COUNCIL ASSESSMENT REPORT

SYDNEY EASTERN CITY PLANNING PANEL

PANEL REFERENCE & DA NUMBER	PPSSEC-117 - DA/642/2020
PROPOSAL	Demolition of existing structures including the existing aged care facility, construction of a 4 storey building over two basement levels for the purposes of seniors housing with ancillary uses, comprising 83 beds (79 rooms) and 2 x 1 bedroom independent living units, rooftop terrace, basement car parking for 18 vehicles, lot consolidation, landscaping and associated works (variation to building height of RLEP 2012).
ADDRESS	11 – 19 Frenchmans Road, Randwick Lot 10 in DP 845575 (11 – 15 Frenchmans Road) Lot 3 in DP 13779 (17 Frenchmans Road) Lot 4 I DP 13779 (19 Frenchmans Road)
APPLICANT	Higgins Planning
OWNER	Frenchmans Lodge Properties Pty Ltd
DA LODGEMENT DATE	25 November 2020
APPLICATION	Development Application
REGIONALLY SIGNIFICANT CRITERIA	SEPP – (State and Regional Development) 2011 - Schedule 7(2): General Development with cost of work greater than \$30m.

SCHEDULED MEETING DATE	28 March 2022
PLAN VERSION	14 February 2022 Version No. D
PREPARED BY	Angela Manahan, Executive Planner
DATE OF REPORT	18 March 2022

Figure 3 - Privacy measures recommended as detailed.

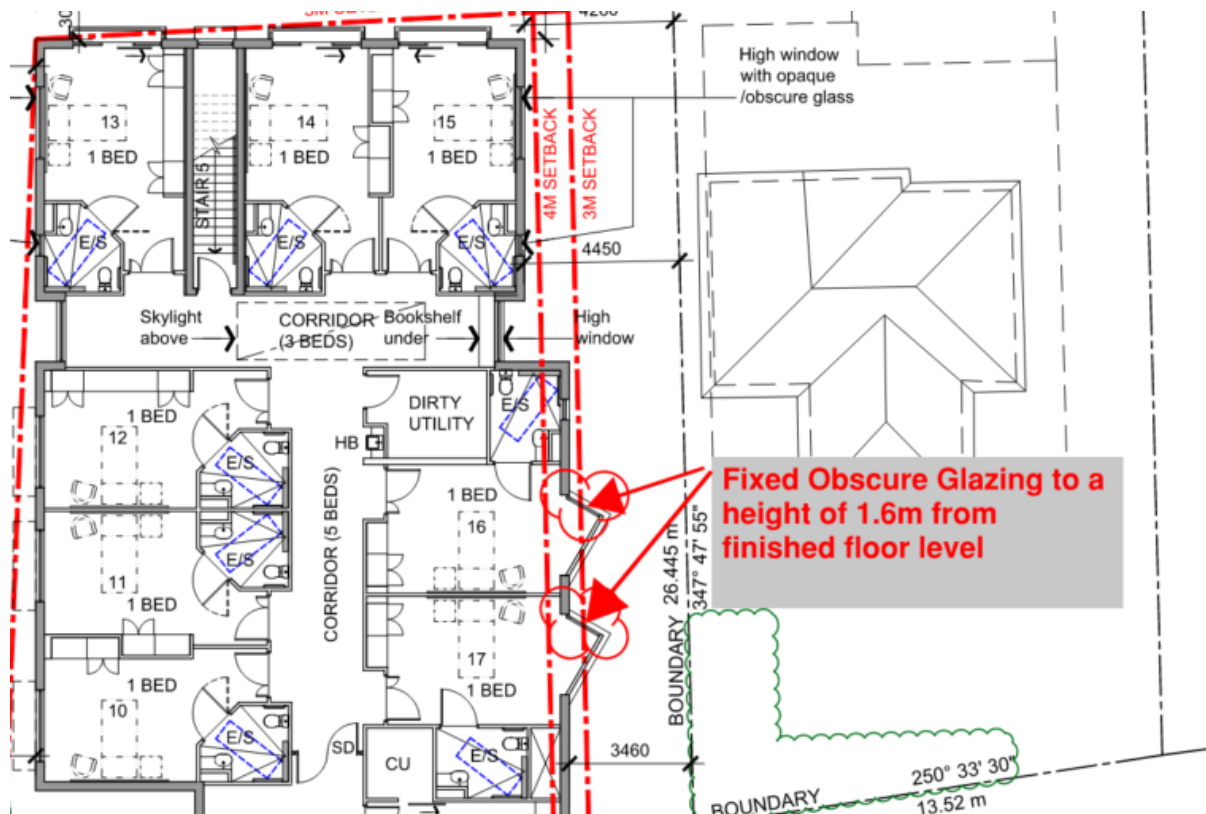
In the amended proposal, the first floor level rooms 16 and 17 within the rear portion of the building propose protruding angled windows which would have the ability to overlook the dwelling and POS of the adjoining property at 25 McLennan Avenue. As such it is recommended that the north-eastern face of those windows be fixed translucent glazing to a minimum height of 1.6m from finished floor level as demonstrated in the following sketch:

In response to concerns raised by neighbouring properties, several privacy measures are also recommended on windows and balconies to side and rear boundaries.

Figure 8 - West Elevation Dwg No. DA13, Rev E dated 14 February 2022.

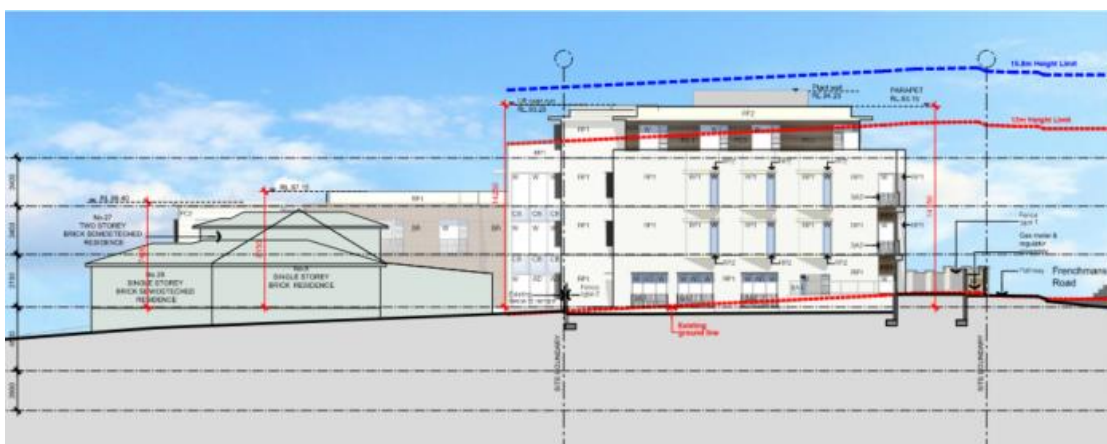
The proposal as amended, seeks a maximum height of 13.59m to the lift overrun, 14.28m the plant acoustic wall, and 13.09m to the ceiling. The following elevations show the height exceedance through the red dashed line. Additionally, the blue dashed line shows the maximum height as permissible under the new Housing SEPP 2021 which is addressed further in the report.
